**Investigation into Alleged Environmental Violations by  
Central Coalfields Ltd in Purnadih OCP:**

**Report of Committee appointed by Hon'ble National Green  
Tribunal in *Sanjay Chauhan vs CCL & Ors (OA 37/2020/EZ)*  
*vide order dt.22.06.2020***

Date of submission: 14 September 2020

**Figure 2. Map (land use plan) of Purnadih OCP as given in the EIA document of 2008, showing location of CHP, railway line including loop (blue arrow).**

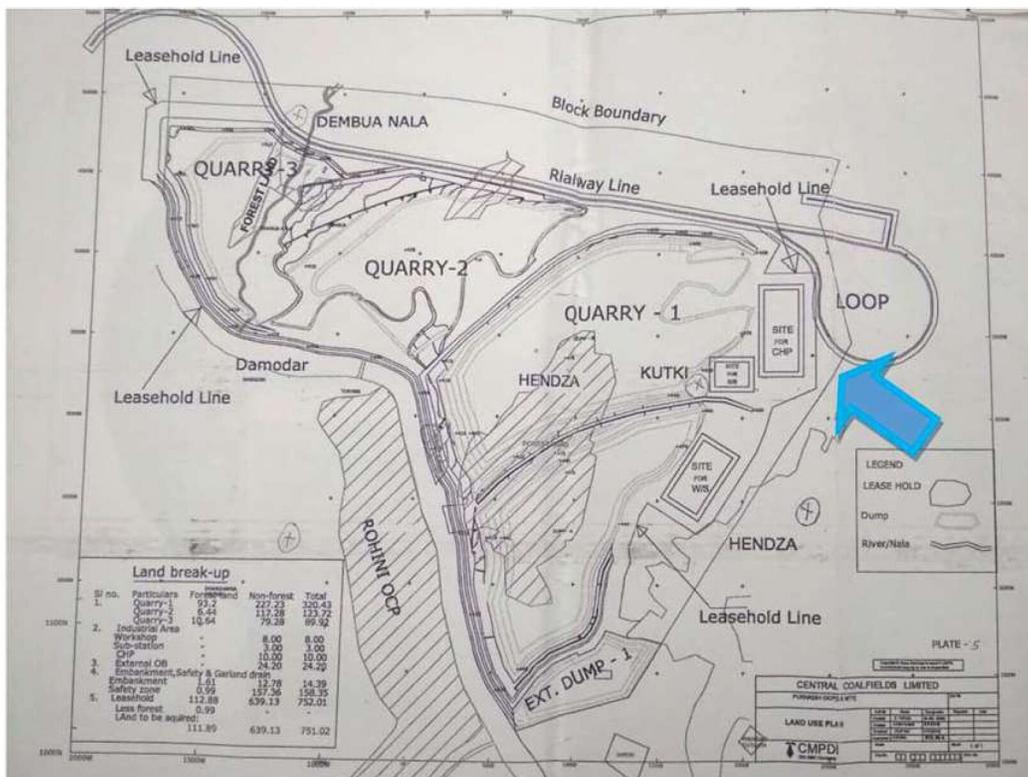
- In the EIA/EMP of 2008 (in the land use plan) it is clearly shown that a CHP was to be constructed in Purnadih project in area of 10 ha (see Figure 2), along with a dedicated rail line with loop to the CHP.
- Further, on page 54 of the EIA/EMP report, it is mentioned that “CHP [will] convey the coal from feeder breaker/crusher to loading point” and describes several arrangements to be made along the conveyor belt, transfer house, and wagon loading point to suppress dust.
- On page 16 on the EIA/EMP report, it is stated that “Railway siding has been planned to serve Ashoka East OCP, Piparwar OCP and this (Purnadih) project, which would run on northern side of the (Purnadih) project. .... However,

- a) **CHP and railway line/siding as shown in the land use plan (Figure 2) have not been constructed. Since 2009 till date, the coal is being transported on trucks to KDH railway siding located approx. 5 km from the mine.**
- b) Furthermore, the field visit showed that road transport of coal was resulting in much spillage of coal on the road. **This coal dust was observed to be flowing off the road into drains, nallahs and even into river Damodar** (see Figure 3-left). In the dry season, this dust will also create serious air pollution.
